SERVICE BULLETIN

NUMBER: 600870-000027
SUBJECT: BIT ADDITION, SQUITTER SUPPRESSION FIX, & STRATUS ESG GPS
IMPROVEMENT
COMPLIANCE LEVEL: OPTIONAL
DATE: 4/05/2018

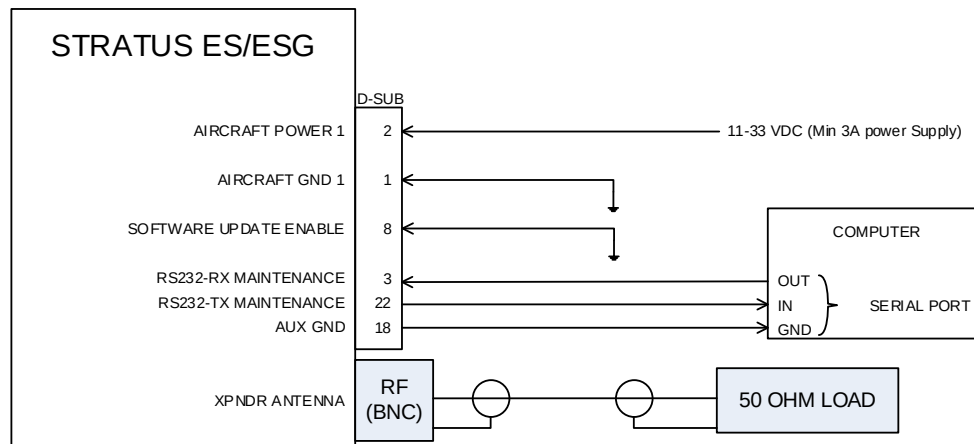
1. Use the following diagram to wire the transponder for a software update.

SOME DETAIL IS REMOVED FOR CLARITY
1 UNLESS OTHERWISE SPECIFIED, ALL WIRING TO BE DONE WITH 22 AWG WIRING
